## PIC12F508/509 Rev. A Silicon/Data Sheet Errata

The PIC12F508/509 parts you have received conform functionally to the Device Data Sheet (DS41236C), except for the anomalies described below.

**FIGURE 1:**

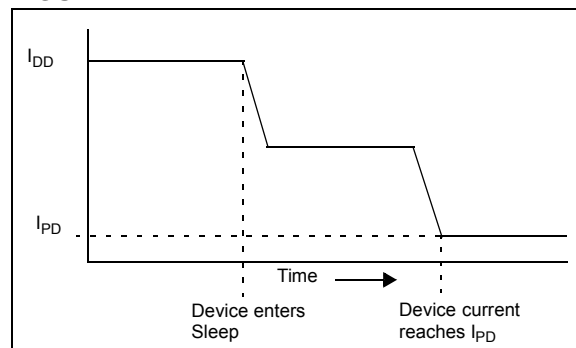
On the PIC12F508/509 silicon, revisions earlier than A3, the power-down base current may remain higher than the specification for a short time when entering Sleep.

The following graph illustrates the device current upon entering Sleep:

The length of time between the device entering Sleep mode and the device current reaching  $I_{PD}$  increases as both temperature and voltage decrease.

This issue is fixed in Revisions A3 and later.
